Value Engineering Study Report

Jefferson County I-264/US 42 Interchange and I-264 Widening
Item No. 5-804.00 and 5-594.00

Study Date: December 8-12, 2014

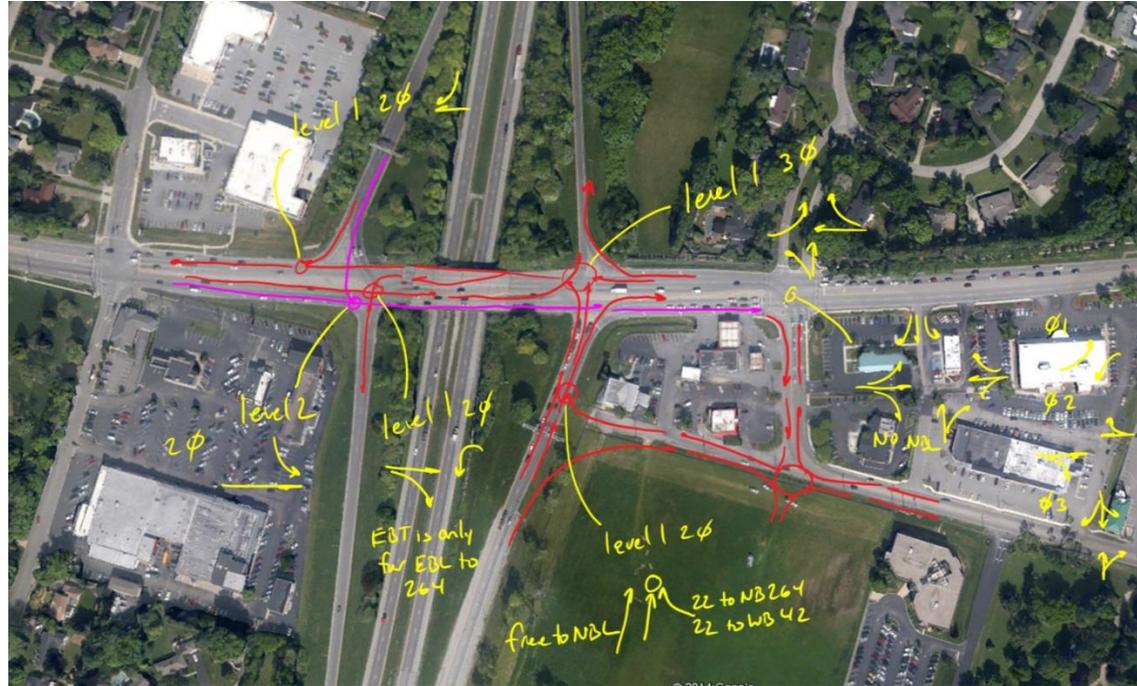
This idea will not work geometrically.

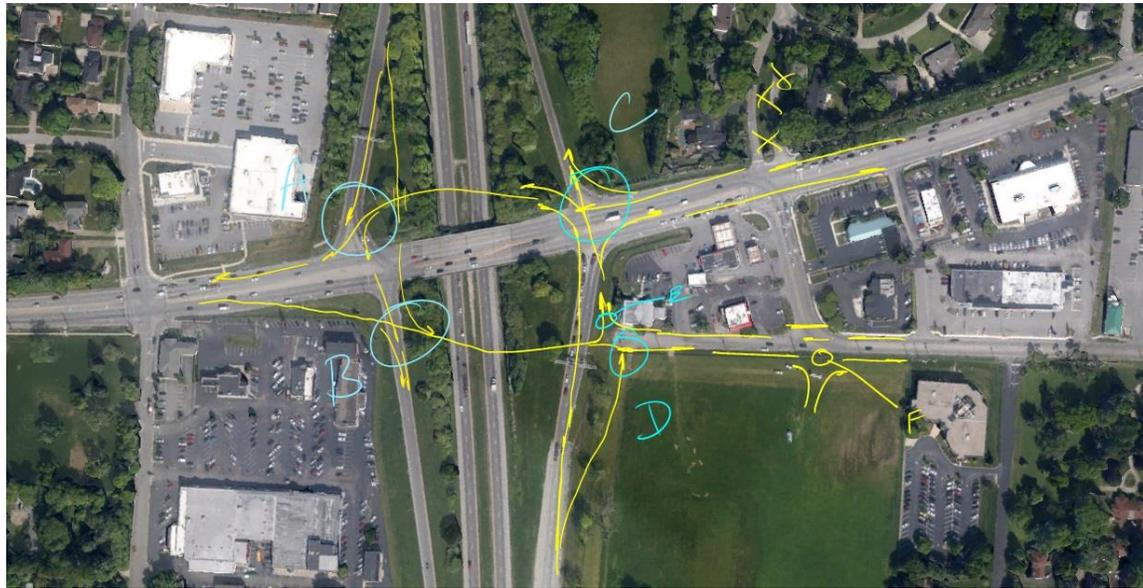
This will not work geometrically
